STAFF RECOMMENDATION

DATE: November 20, 2019

CASE FILE NO.: Z0442-19-D

PROPOSAL: Design review of a new building of approximately 7,500 square feet to be used for general goods retail, along with related site improvements. The proposal includes a new building, site access, circulation, parking, landscaping, and other redevelopment as required by the Clackamas County Zoning and Development Ordinance.

Building Elevations

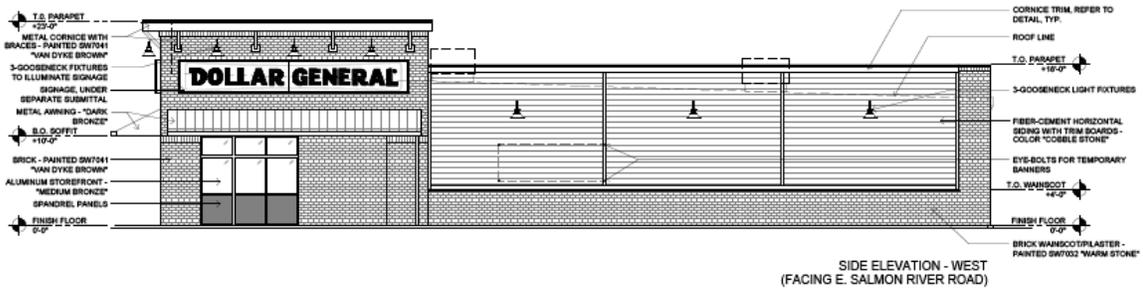
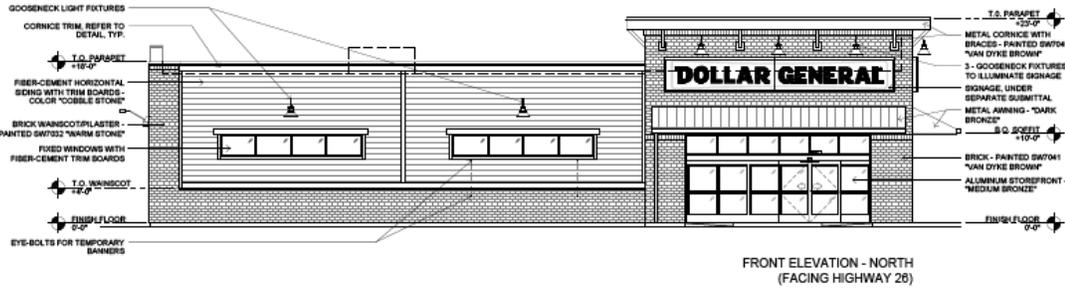
Finding: The building is designed with articulation of the façade and architectural emphasis. Human scale and proportion is used in the placement of windows, and the size of the brick finish used on the knee wall and at the building corners. The entrance has a projecting awning to shield customers at entry. The flat roof of the structure is surrounded by a cornice and architectural treatment which provides visual interest. The design uses colors that are neutral and appropriate to the rural context and building forms which are suggestive of the arts-and-crafts style common to the area and Cascadian architecture. The design of the building is consistent with its proposed use and level of public exposure. The façade materials are consistent with the commercial identity of the rural mountain communities, are durable, and consistent with the proposed use of the building. Per the above findings and the applicant’s submitted drawings, the proposed building complies with the relevant standards of section 1005.04. These standards are met.

Landscape Plan

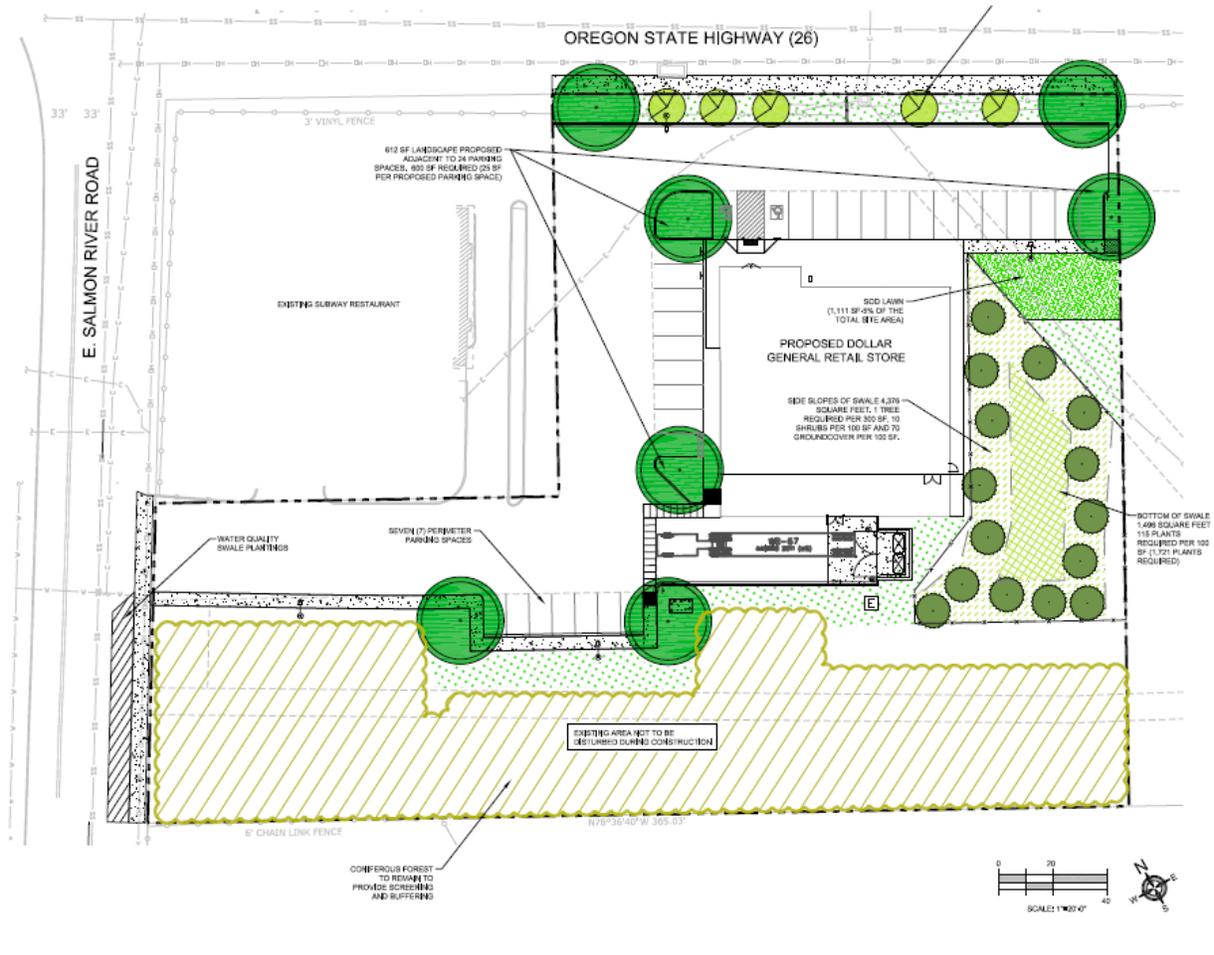
Finding: The proposed site design increases the landscaped area while retaining the existing natural and mature landscape along the southern boundary of the site. The site will exceed the 15% requirement of the design standards. A variety of plants of various sizes, textures, and seasonal interest are indicated, none of which are invasive or noxious species. These species are predominantly native and/or drought tolerant plants, appropriate to a commercial context and the local habitat/conditions. Conditions of approval will ensure compliance with the required landscaping in terms of composition of materials, installation and maintenance of landscape, and irrigation. US 26 is identified as a Scenic Road in Comprehensive Plan Map V-1, however the setback requirements described in 1009.05, do not apply to development within the RTC zone. **With the conditions of approval in Section 2, the above findings and the applicant's submitted drawings, the proposed development meets the standards. As conditioned, these standards are met.**

1. Prior to issuance of building permit, the applicant shall submit a site drawing demonstrating a landscape irrigation system which meets the standards of ZDO 1009.10(M).
